Access Compliance Report

Public Rights-of-Way

Intersection ID: 47775	Main Street: TRAILMOOR_RD	Cross Street: BEREWICK_COMMONS_PY	Location: SW
ADA ID: 777F67539907	Ramp Type: PerpDiag	Initial Pass/Fail: Fail	Overall Compliance: No
Severity Score: 37.5			
Codes/Mitigation Info/Possible Solution		Field Measurements/Component Compliance

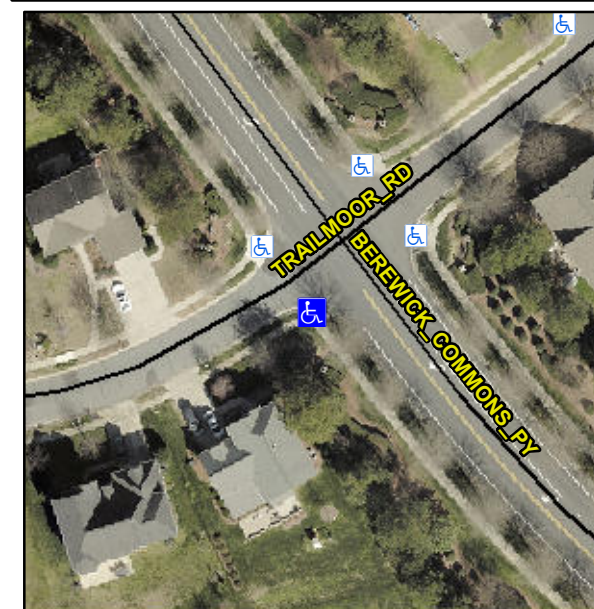
Not Found, R304.2.2, R304.5.3

Compliance	Description	Data	Compliance	Description	Data
N/A	Ramp Length (in)	48.0	No	Ramp Slope (%)	11.1
Yes	Ramp Width (in)	48.0	No	Ramp XSlope (%)	7.5
N/A	Flare Type LT	N/A	N/A	Flare Type RT	N/A
N/A	Flare Slope LT (%)	N/A	N/A	Flare Slope RT (%)	N/A
N/A	Flare Traversable LT?	N/A	N/A	Flare Traversable RT?	N/A
N/A	Landing Length (in)	N/A	N/A	DWS Provided?	N/A
N/A	Landing Width (in)	N/A	N/A	DWS Contrast?	N/A
N/A	Landing Slope (%)	N/A	N/A	DWS Length (in)	N/A
N/A	Landing X Slope (%)	N/A	N/A	DWS Full Width?	N/A
N/A	Landing Curb? (Y/N)	N/A	N/A	DWS Offset (in)	N/A
N/A	Shared Landing?	N/A			
N/A	Gutter Ponding?	N/A	N/A	Gutter Slope (%)	N/A
N/A	Gutter Lip Ht (in)	N/A	N/A	Gutter X Slope (%)	N/A
N/A	Painted X Walk1?	No	N/A	Painted X Walk2?	No
	X Walk 1 Direction	To NE		X Walk 2 Direction	To NW
N/A	X Walk 1 Width (in)	N/A	N/A	X Walk 2 Width (in)	N/A
	X Walk 1 Slope (%)	7.4		X Walk 2 Slope (%)	1.0
	X Walk 1 X Slope (%)	3.3		X Walk 2 X Slope (%)	6.0

Remove & Replace Curb Ramp With Two New Directional Ramps or Equivalent.
